August 20, 2018
BOARD OF COUNTY COMMISSIONERS
ORANGE COUNTY, FLORIDA
Addendum No. 1, IFB Y18-789-EB
BARBER PARK PLAYGROUND IMPROVEMENTS

Bid Opening Date: August 30, 2018

CONSTRUCTION PLANS FOR ORANGE COUNTY PARKS & RECREATION BARBER PARK PLAYGROUND IMPROVEMENTS DISTRICT NUMBER 3 ORANGE COUNTY, FLORIDA

PLAYGROUND LAYOUT & COMPONENTS
SHEET NUMBER
P. 3
OF 19 SHEETS

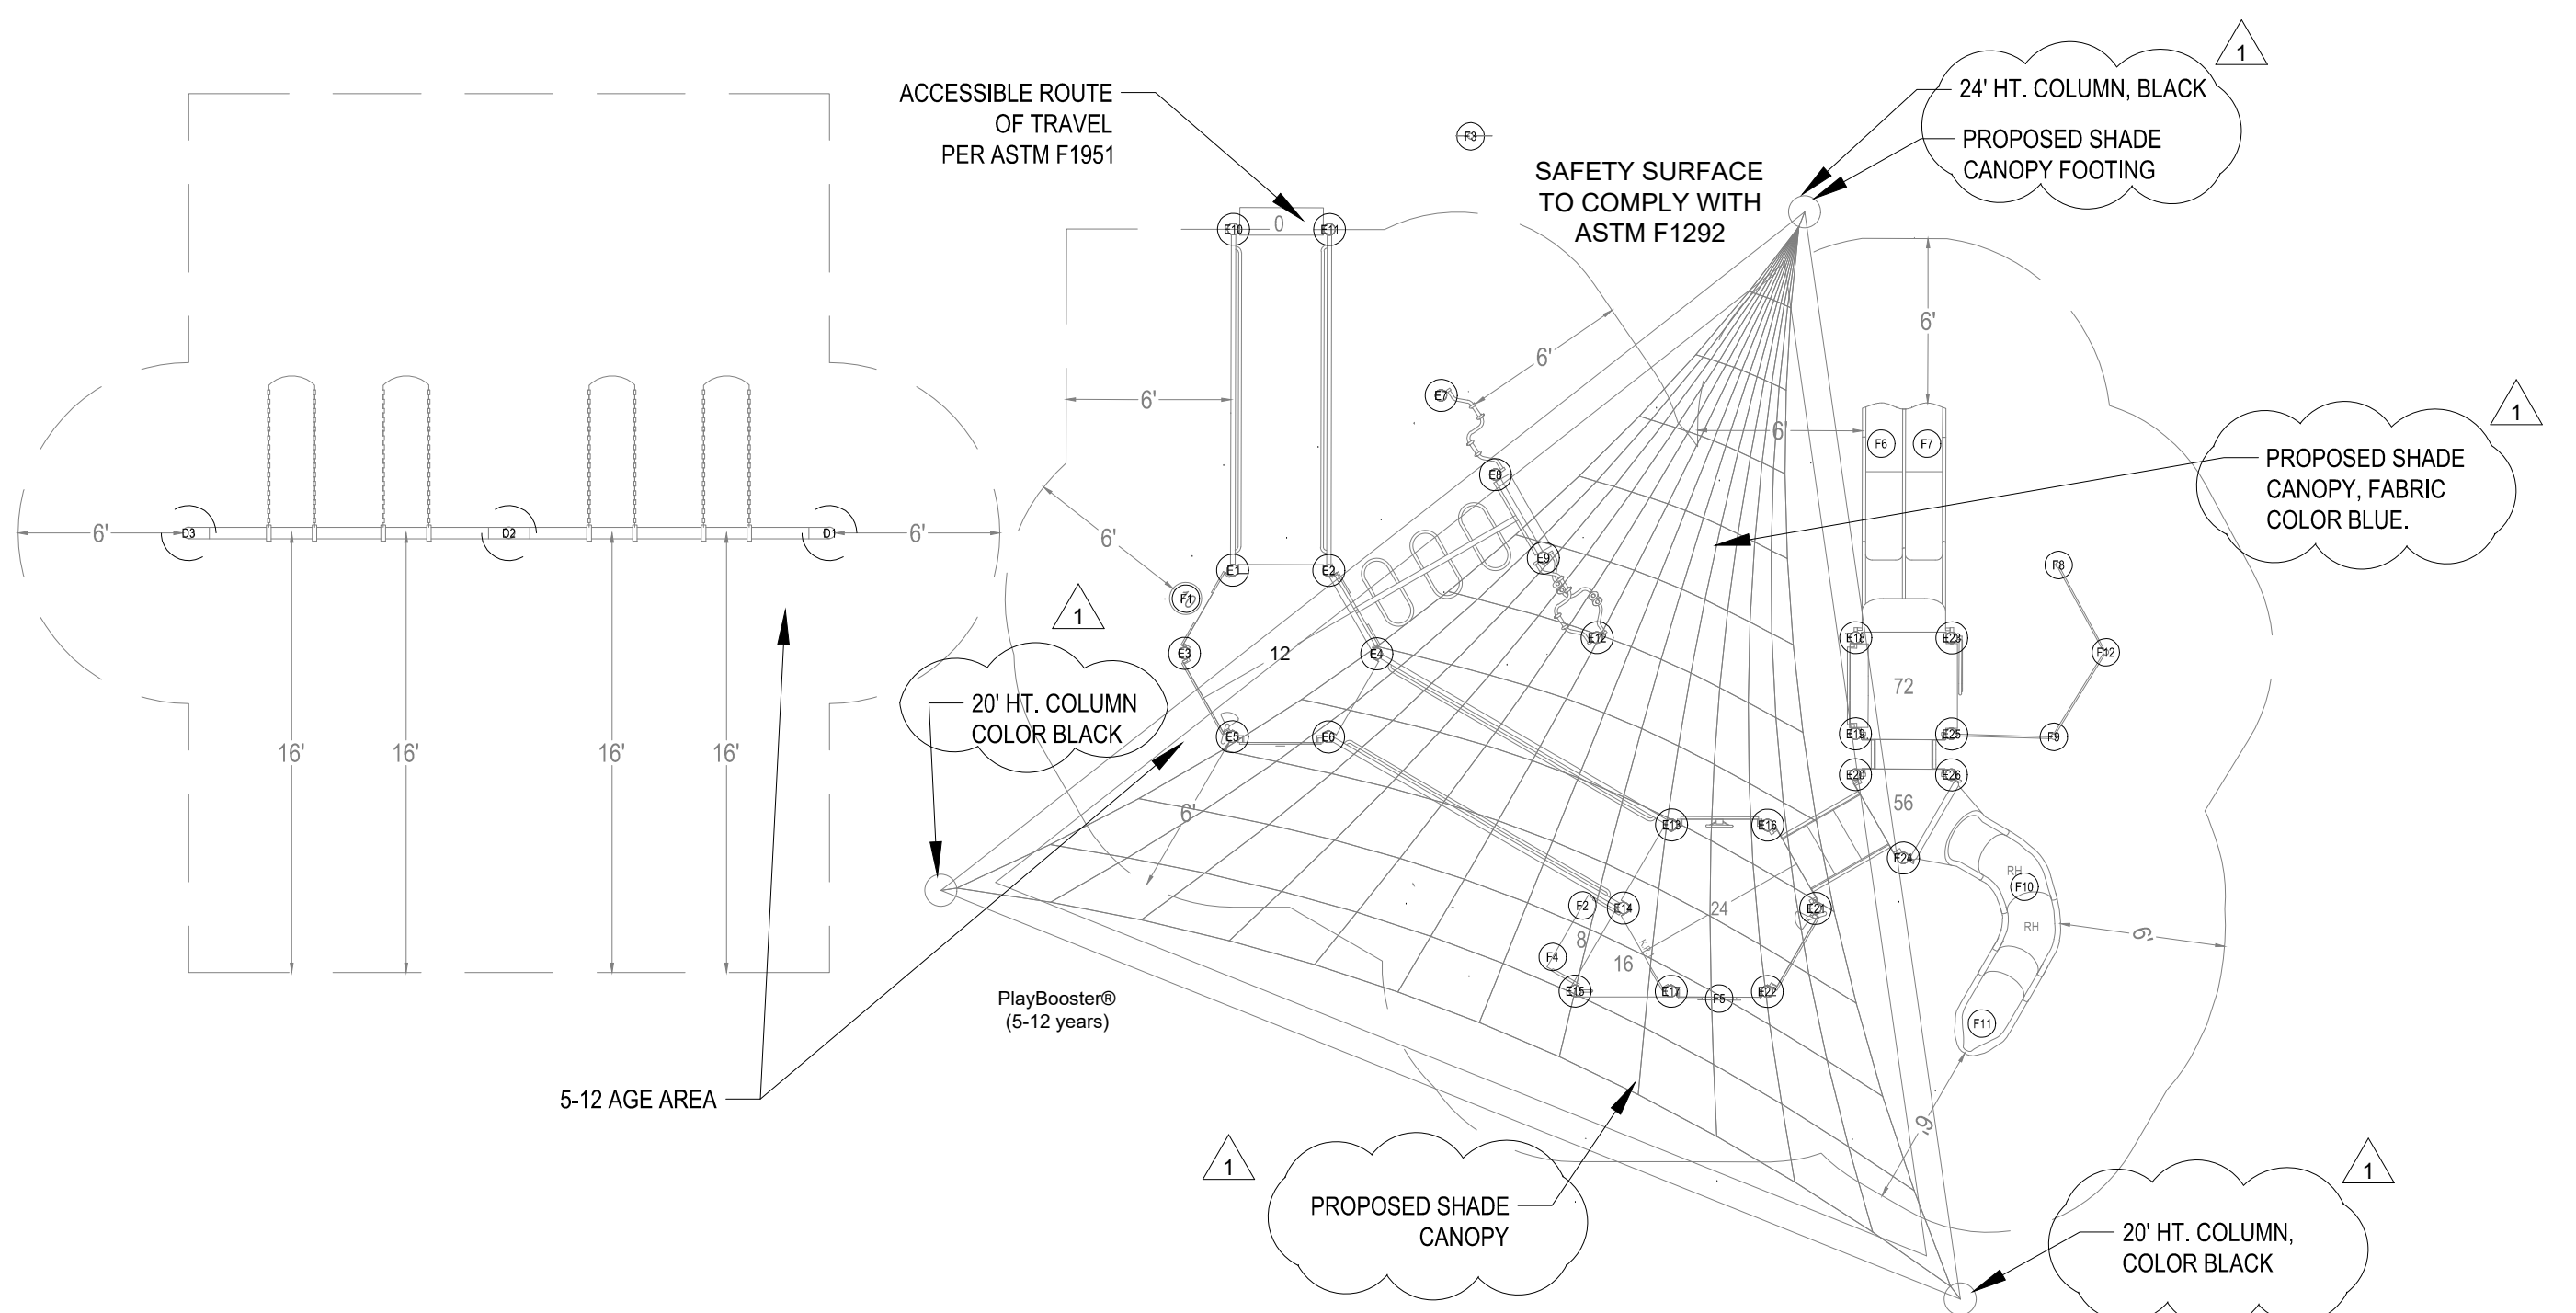
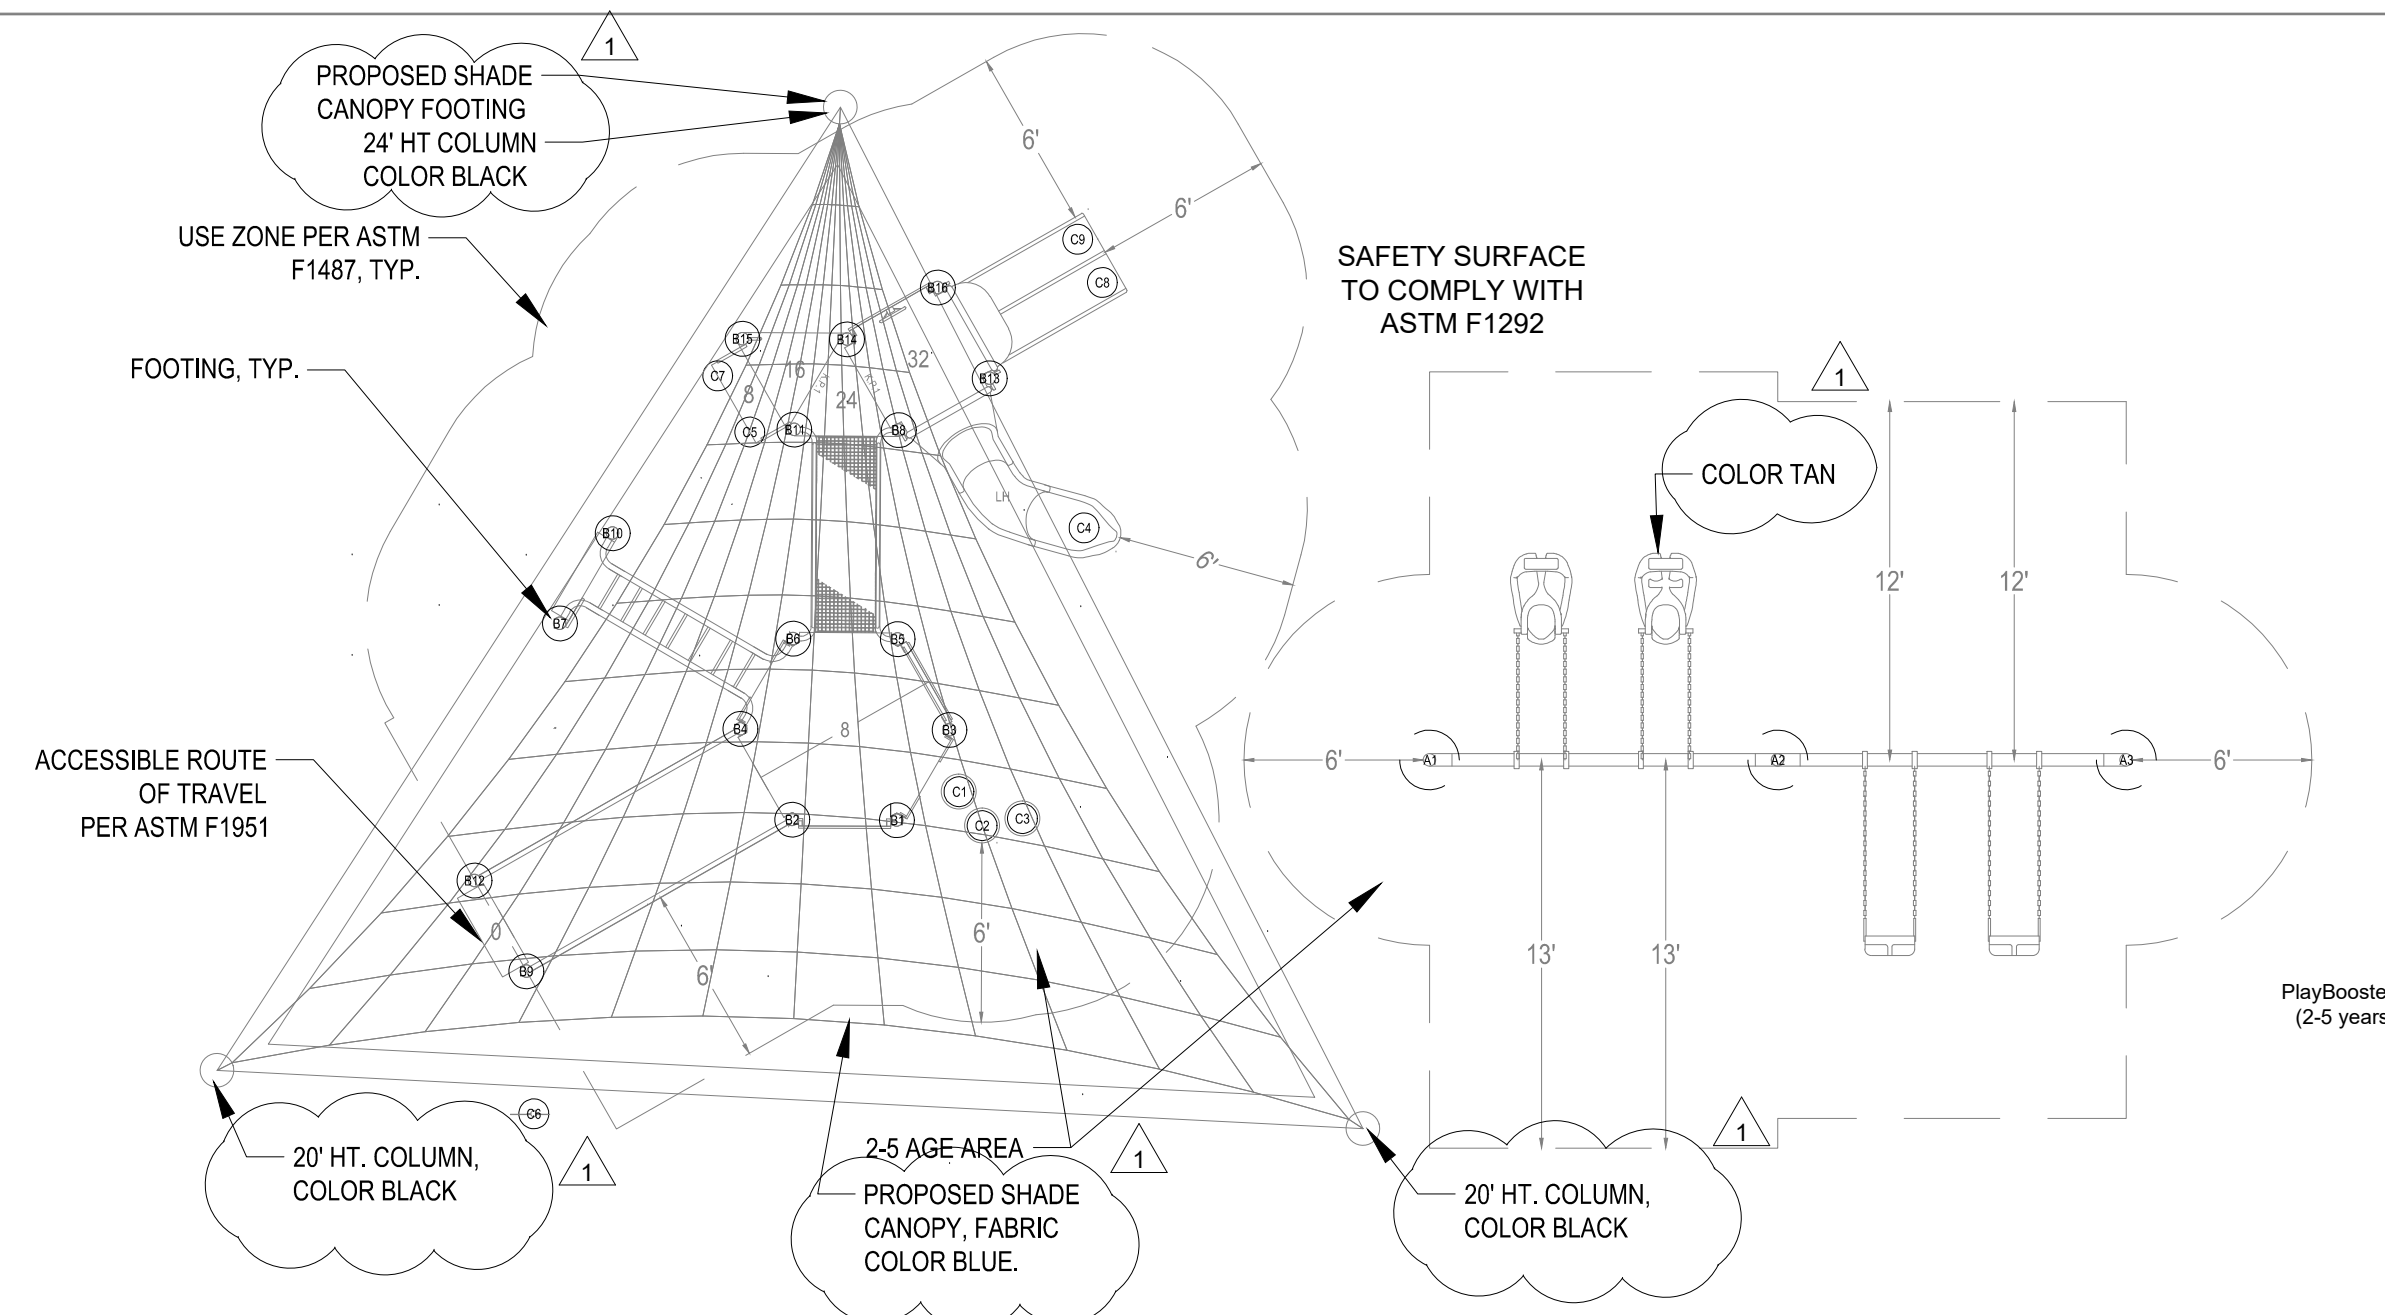
- Shade sail color added
 - Column height and color added
 - Basis of design added
- Sheet P.3 Playground Layout & Components
 - Dimensions removed
 - Safety Surface area revised

SHADE STRUCTURE FOOTING
NTS

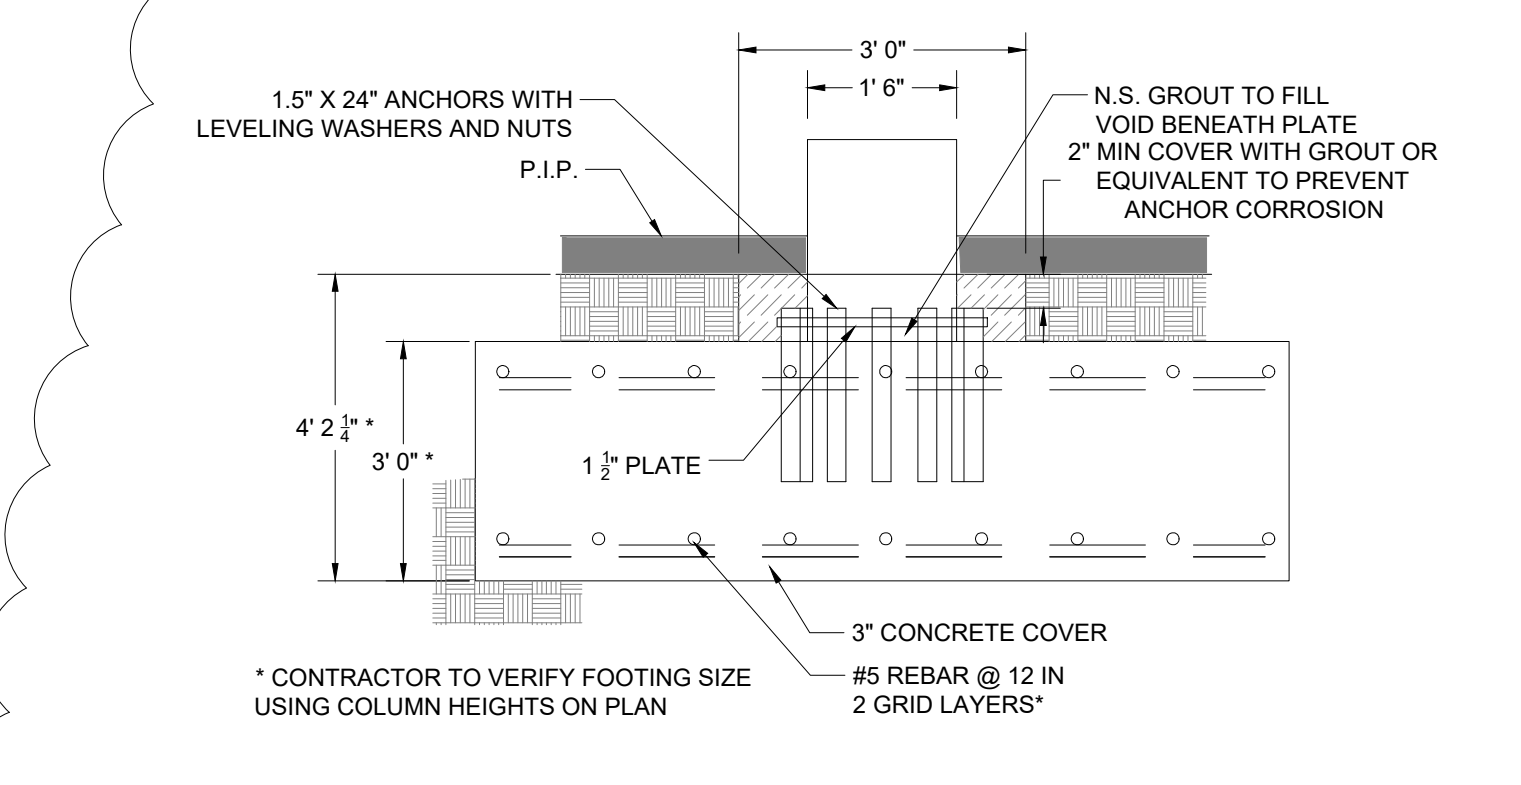
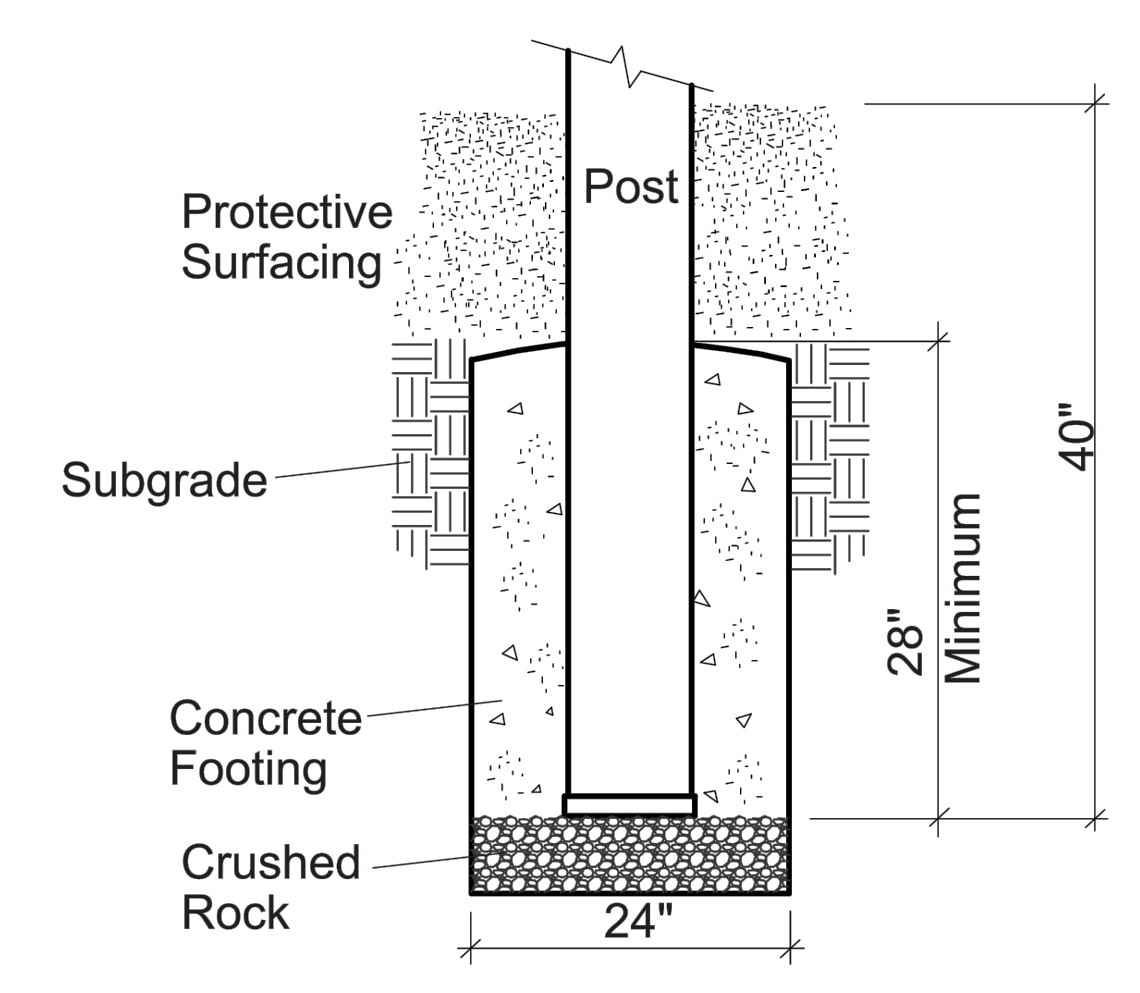
- Sheet P.4 Details – Playground Equipment Footings
 - Column heights and color added
 - Shade sail color added

- Shade structure footing detail revised: note added, and dimensions revised, PIP added.
- Sheet P.5 Details – Playground Equipment List
 - Title block revision for Addendum #1 – no other changes.
- Sheet P.6 Playground Renderings
 - New sheet added
- Sheet P.7 Details & Specs – Shade Structure
 - New sheet added
